The Town of Hilton Head Island  
**Design Review Board Regular Meeting**  
**Tuesday, February 25, 2020 – 1:15 p.m.**  
Benjamin M. Racusin Council Chambers

**REVISED AGENDA**

## **MEETING MINUTES**

**Proposed Exterior Colors & Materials**

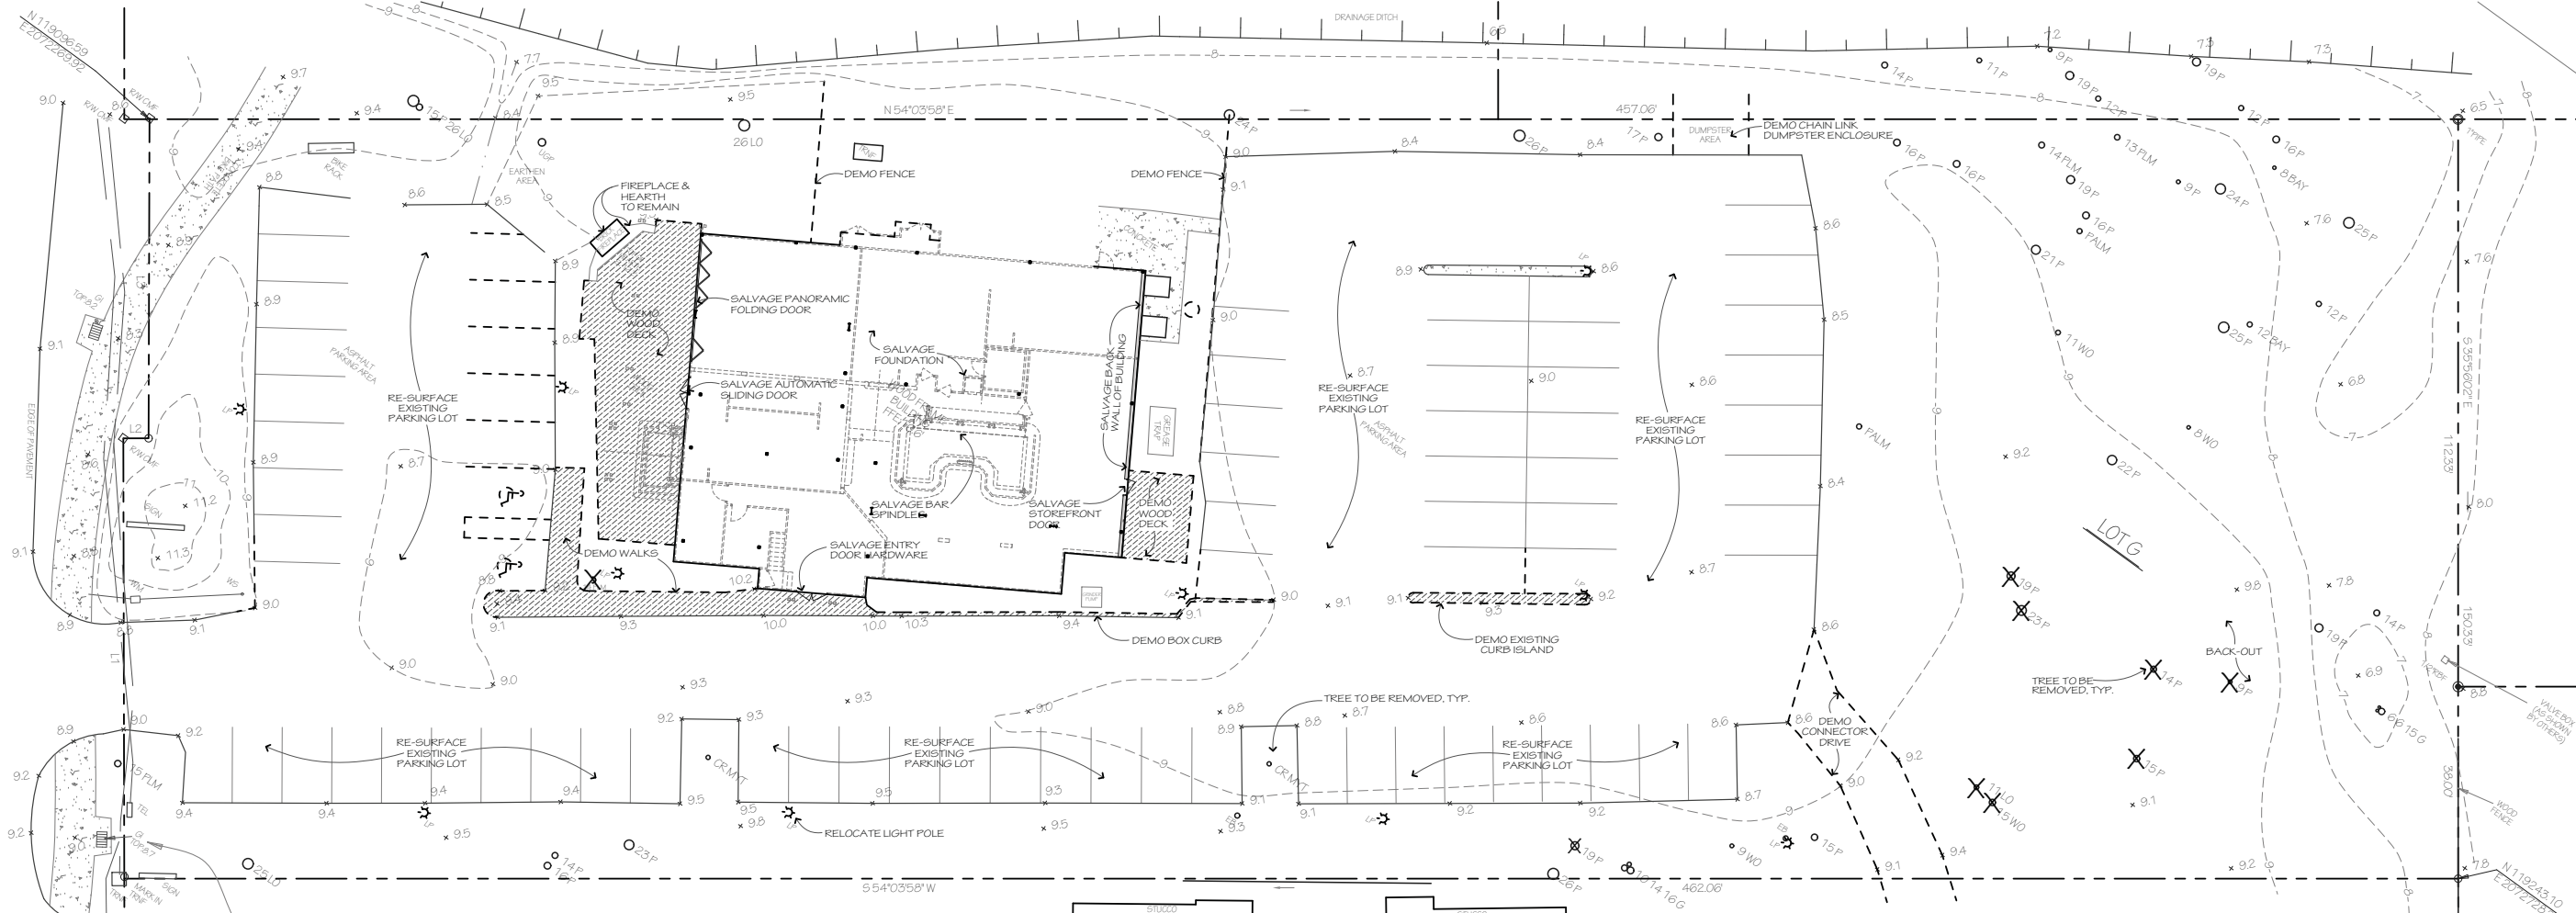
- o The siding will be stained Cabot Dark Gray. Please reference the color board.
4. Increase the planting bed at the front to be a minimum width of 30 inches.

**TREE PROTECTION & REMOVAL AND SEDIMENT & EROSION CONTROL PLAN**  
**2 OF 5**

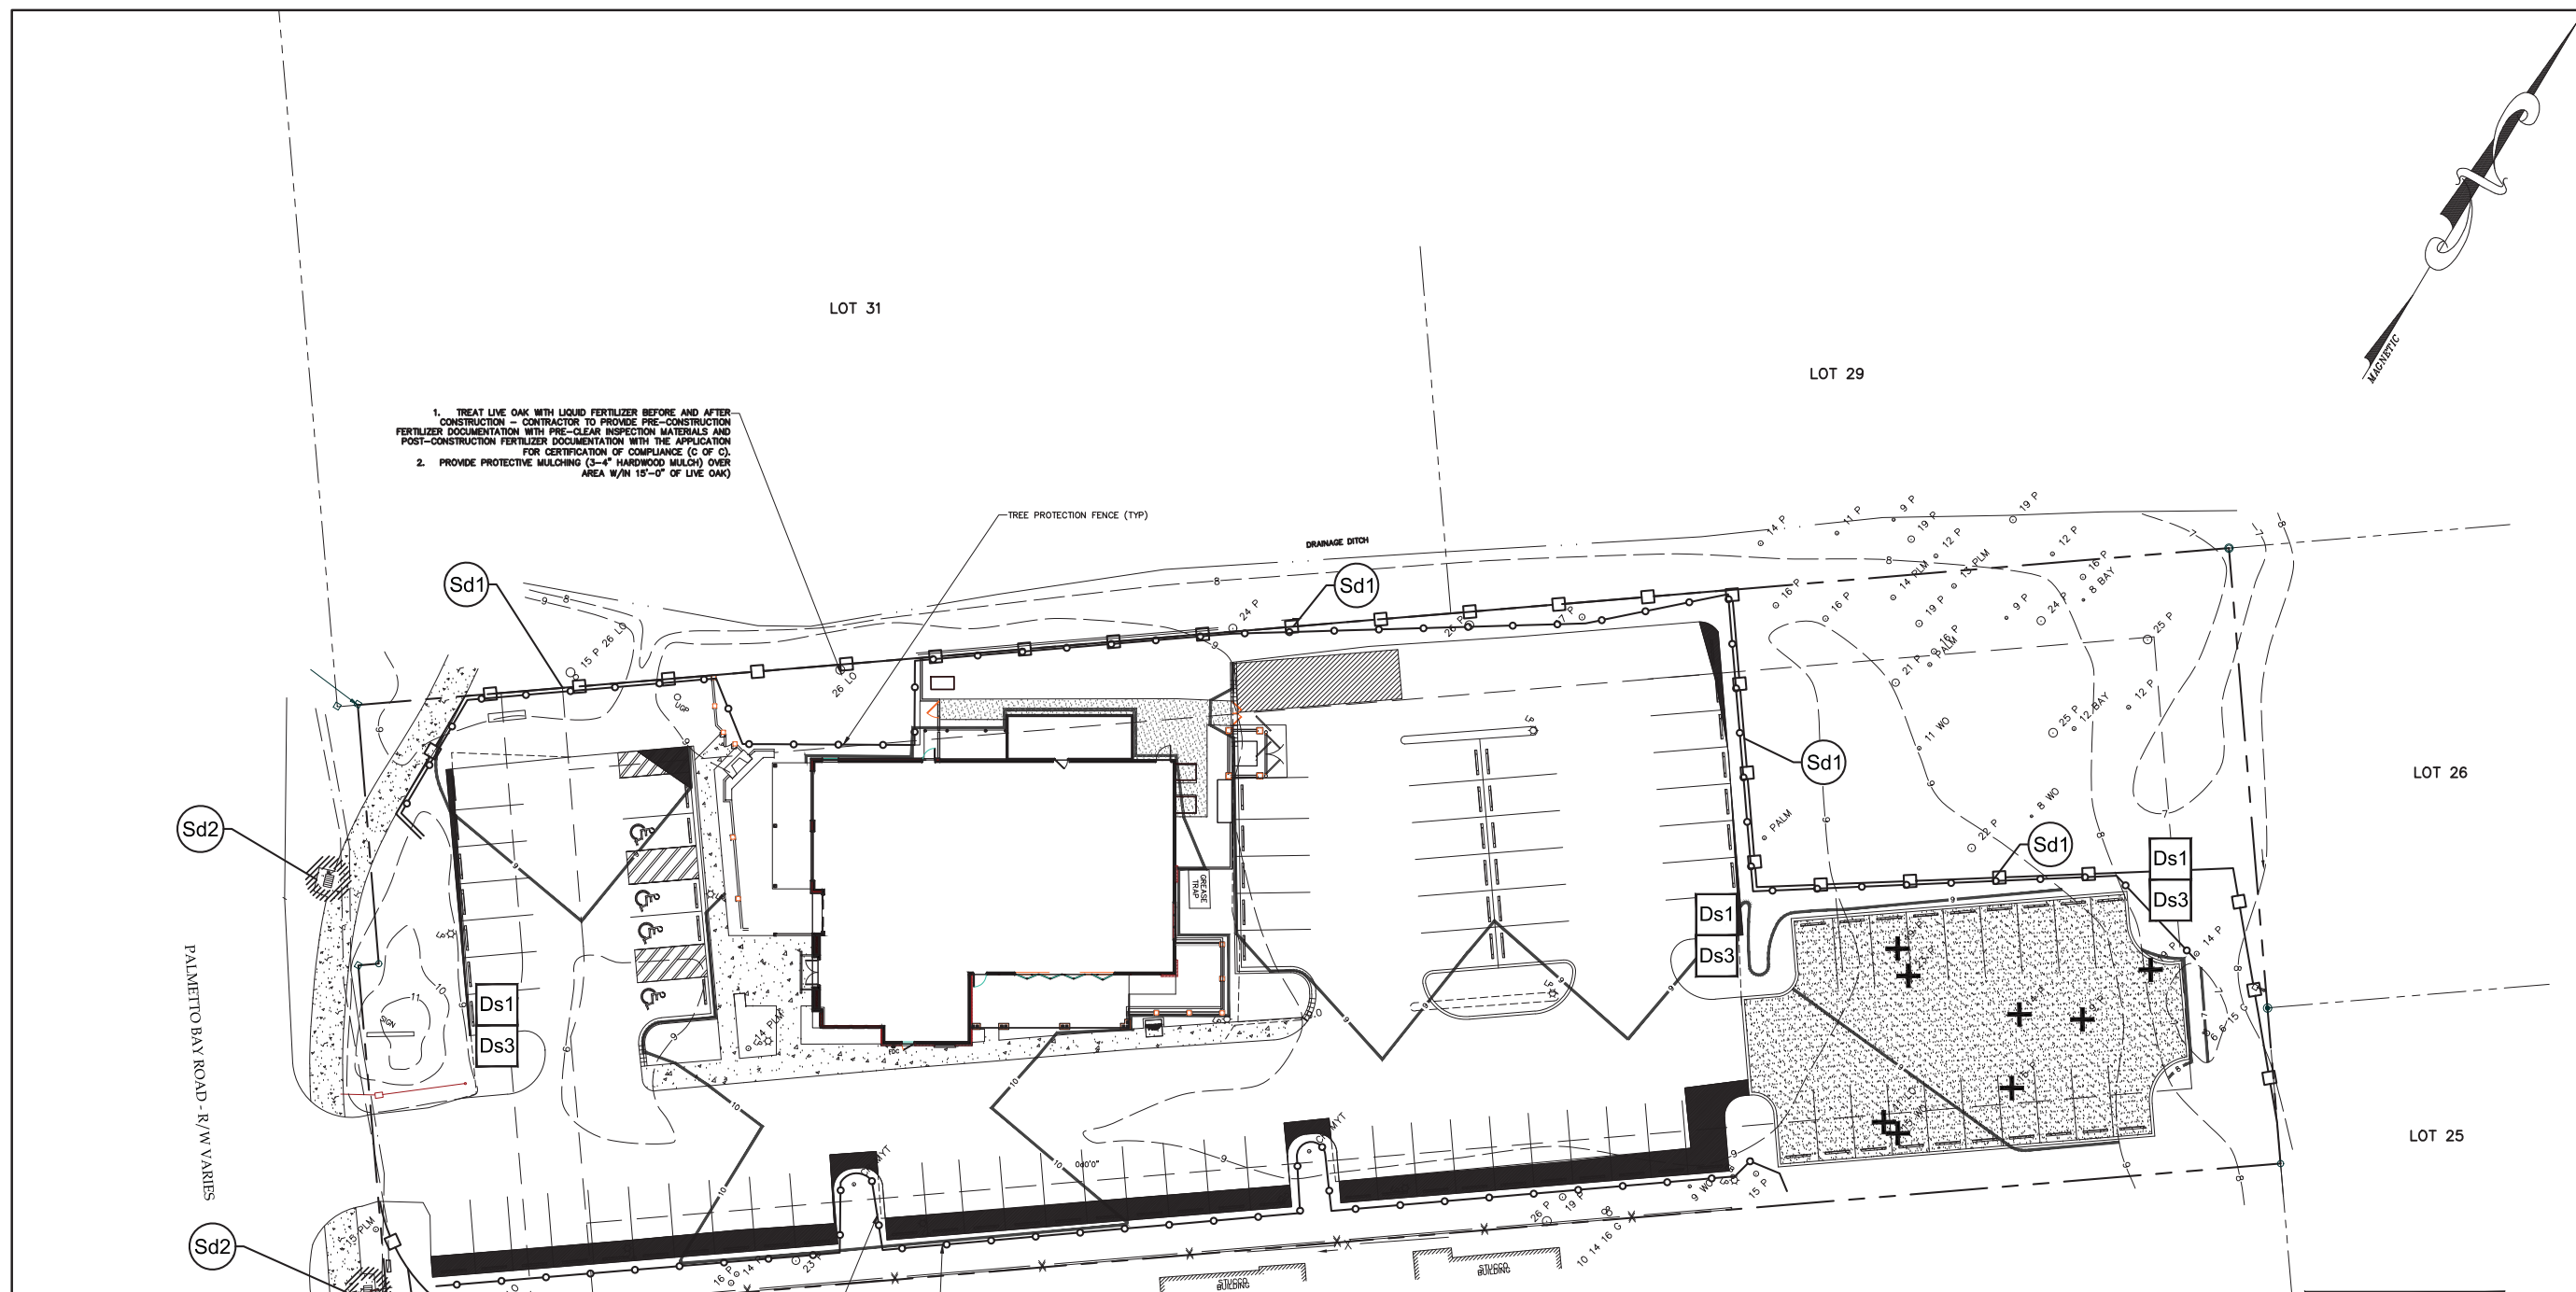
- o The front deck has been reconfigured to expand the planting bed to 30 inches.
5. Update the Tree Protection & Removal Plan to specify pre and post construction fertilization, root stimulant, and protective mulching of the 26" live oak per the DRB conceptual approval conditions.

- o The Tree Protection and Removal Plan (Civil sheet 2 of 5) has been updated to include indicate these tree protection considerations.
6. Replace the Black Fox color with Sierra Pacific Bronze 024 as submitted.

- TREAT LIVE OAK WITH LIQUID FERTILIZER BEFORE AND AFTER CONSTRUCTION - CONTRACTOR TO PROVIDE PRE-CONSTRUCTION FERTILIZER DOCUMENTATION WITH PRE-CLEAR INSPECTION MATERIALS AND POST-CONSTRUCTION FERTILIZER DOCUMENTATION WITH THE APPLICATION FOR CERTIFICATION OF COMPLIANCE (O OF C).
- PROVIDE PROTECTIVE MULCHING (3-4" HARDWOOD MULCH) OVER AREA W/IN 15'-0" OF LIVE OAK

Landscape  
Plan

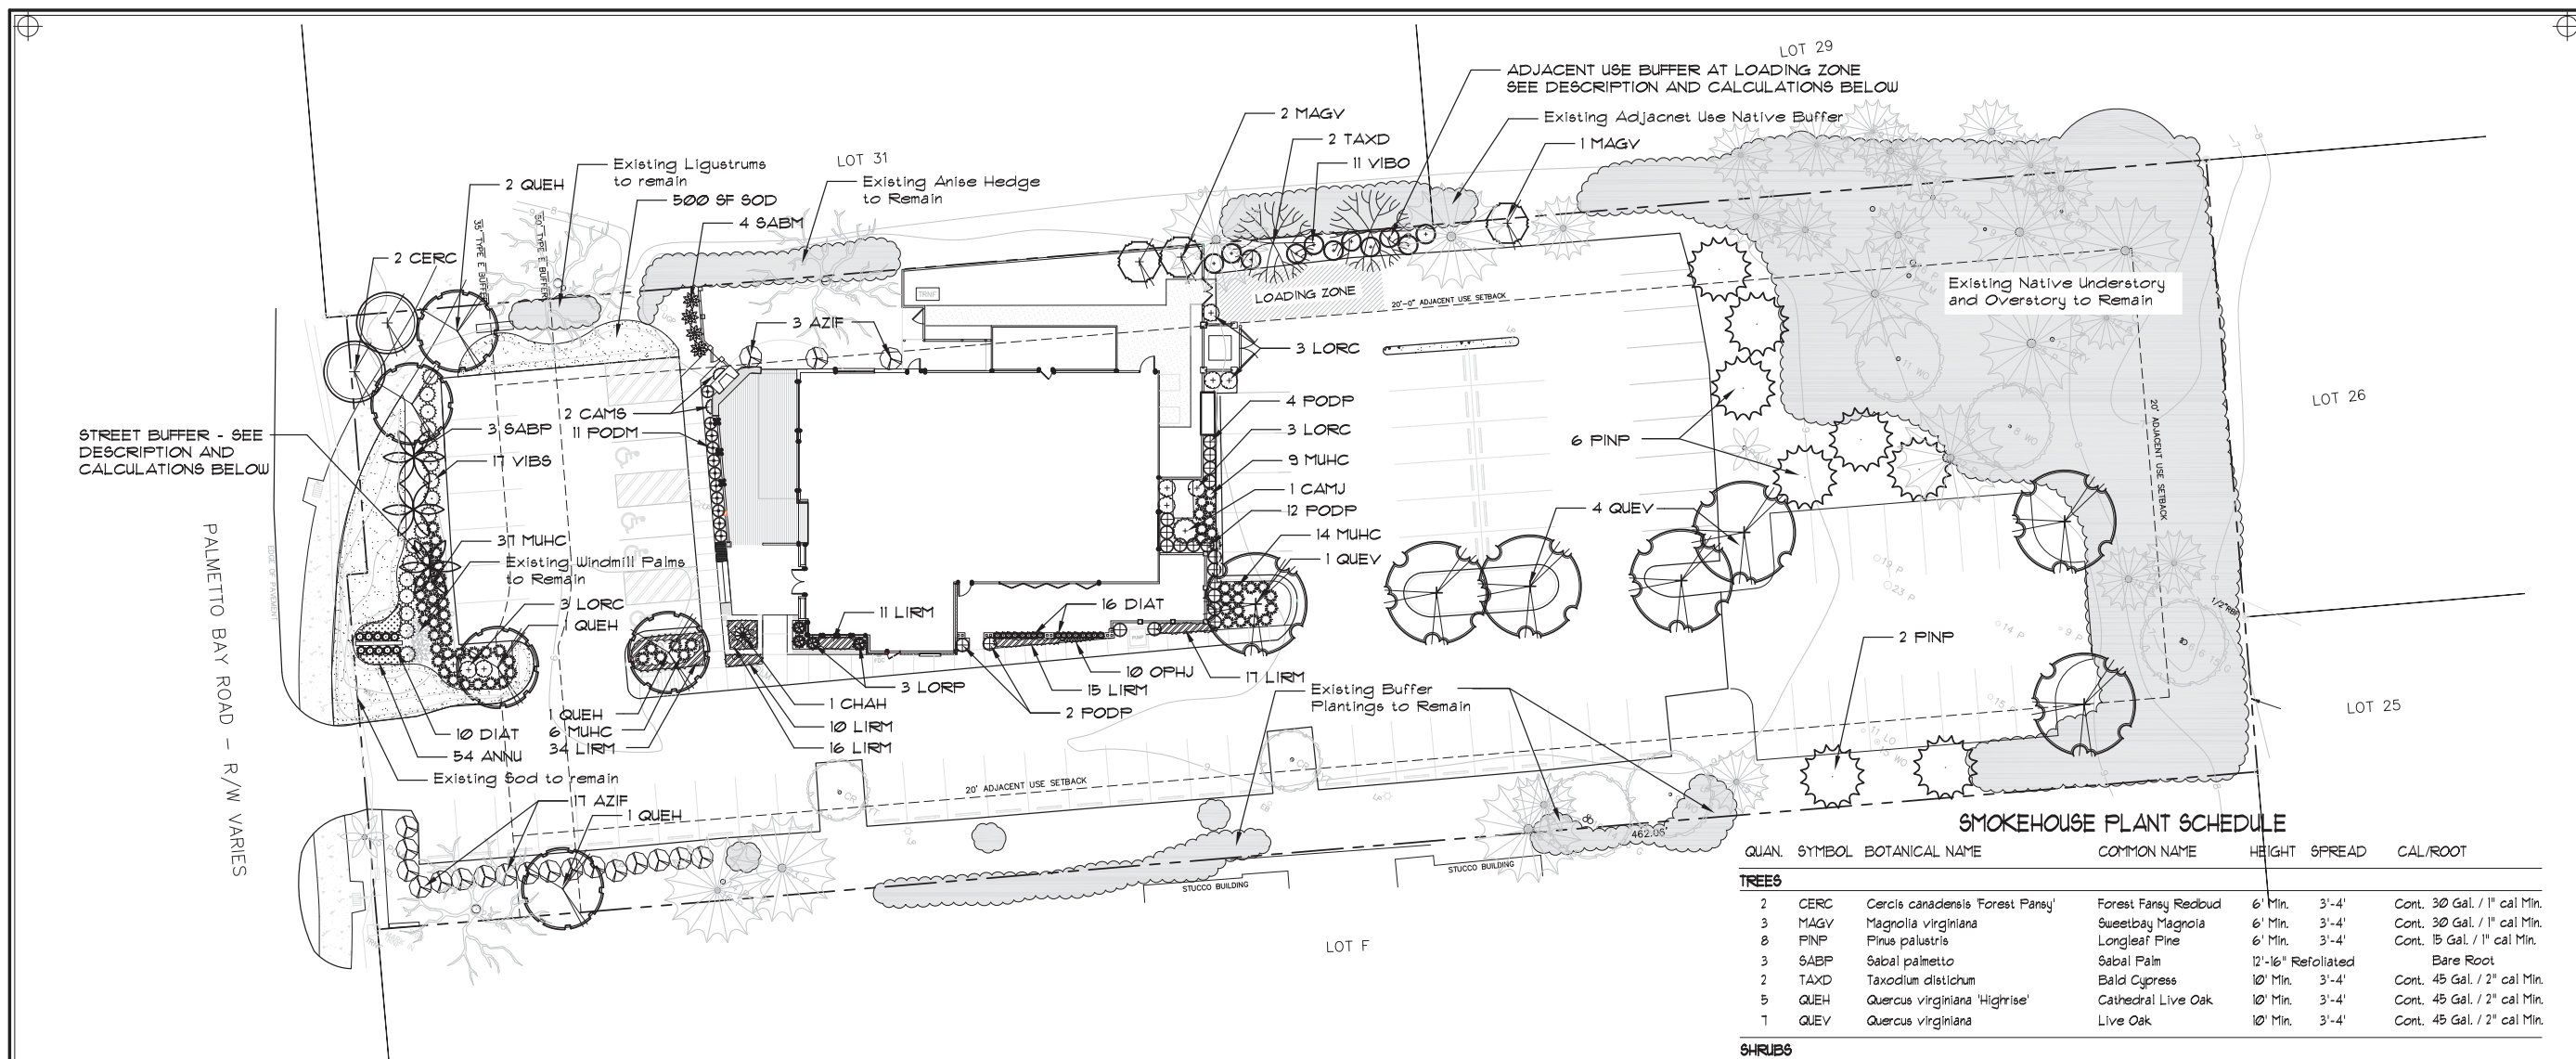
REVISIONS:	NO.	DESCRIPTION:
DATE:	1	Added 1 overstory tree in street buffer, adjust buffer widths, added QUEH & FODM along front elevation per DBS comments.
	2

ELEVATIONS  
**A2.1**

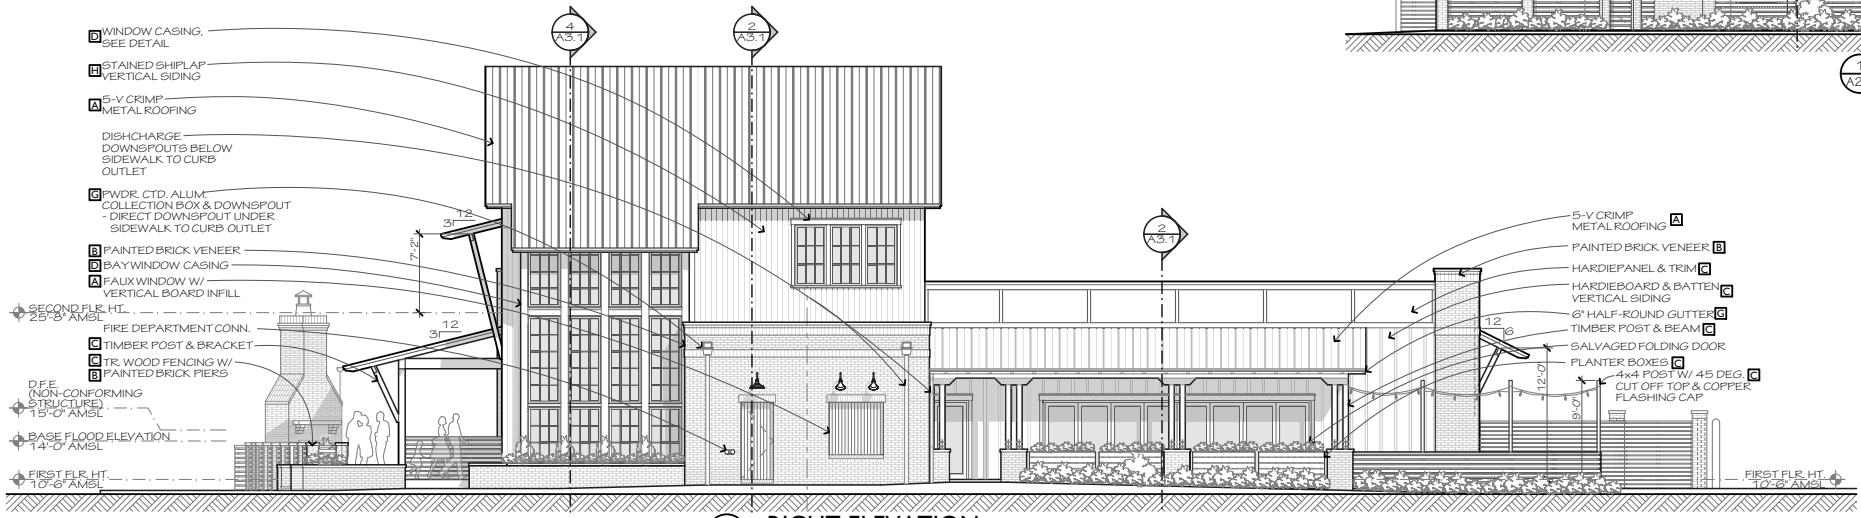
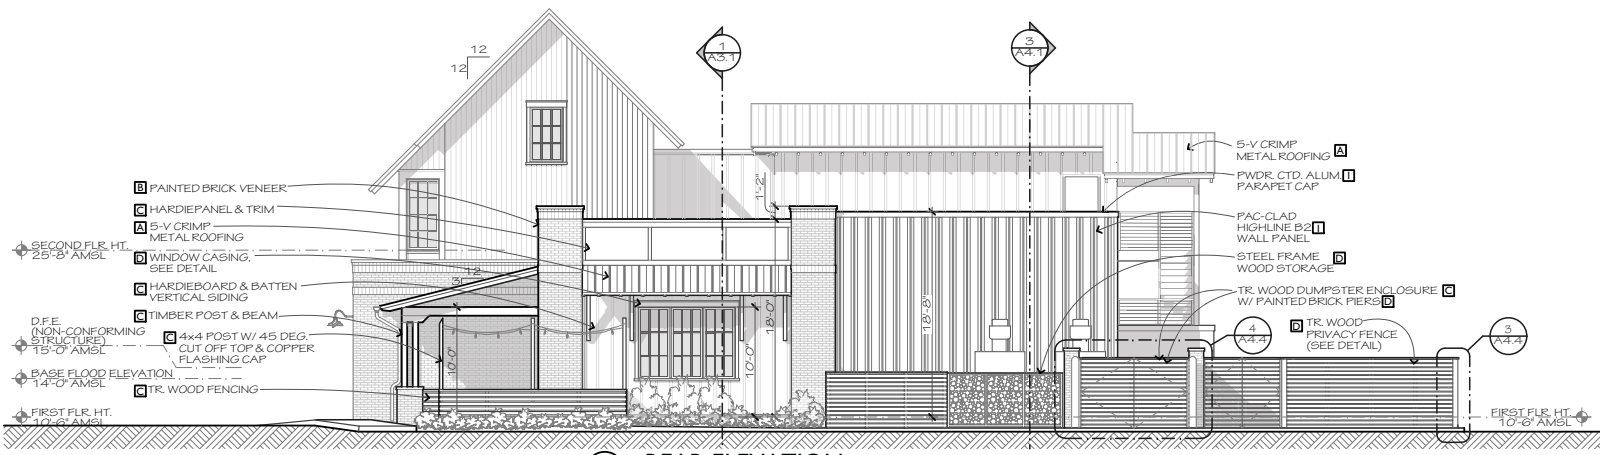
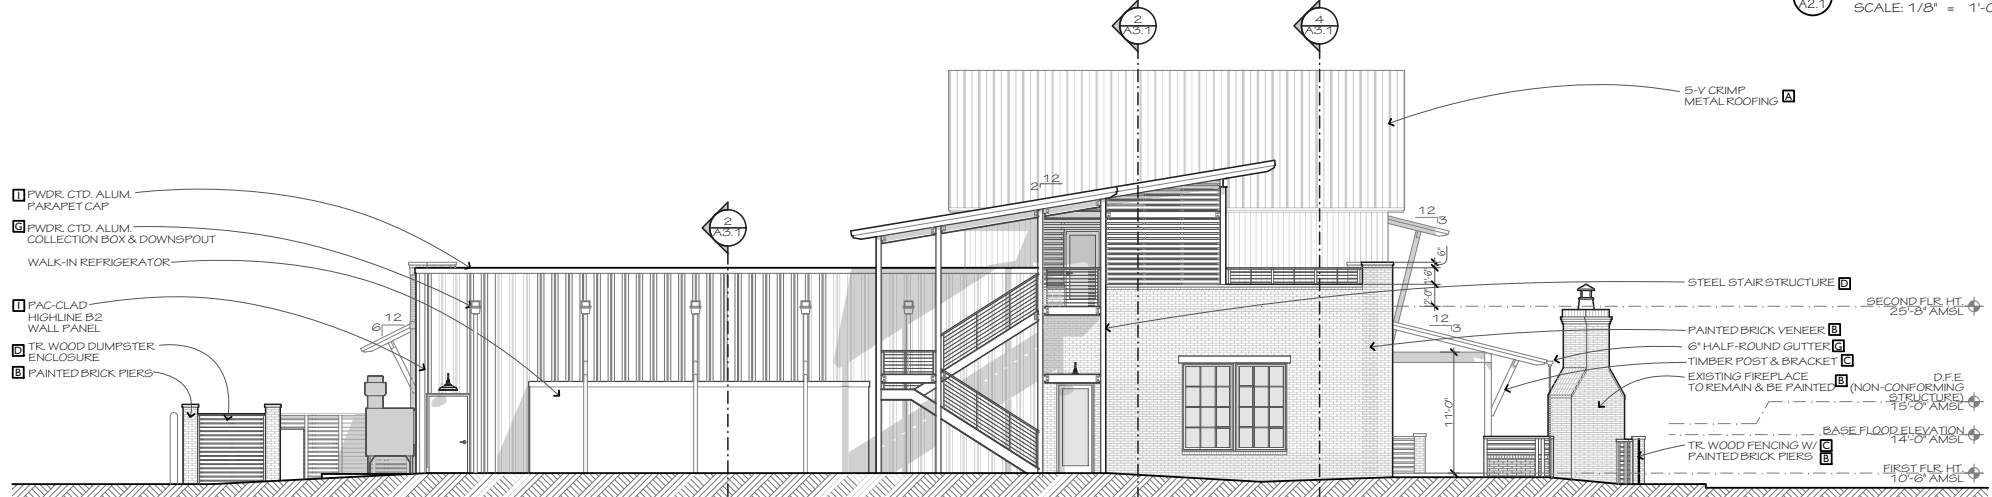
- Exterior lighting on building to follow the elevations shown on sheet A2.1, remove four lights from office level floor plan.
- Provide a cut sheet for ceiling fans for Staff review and approval.
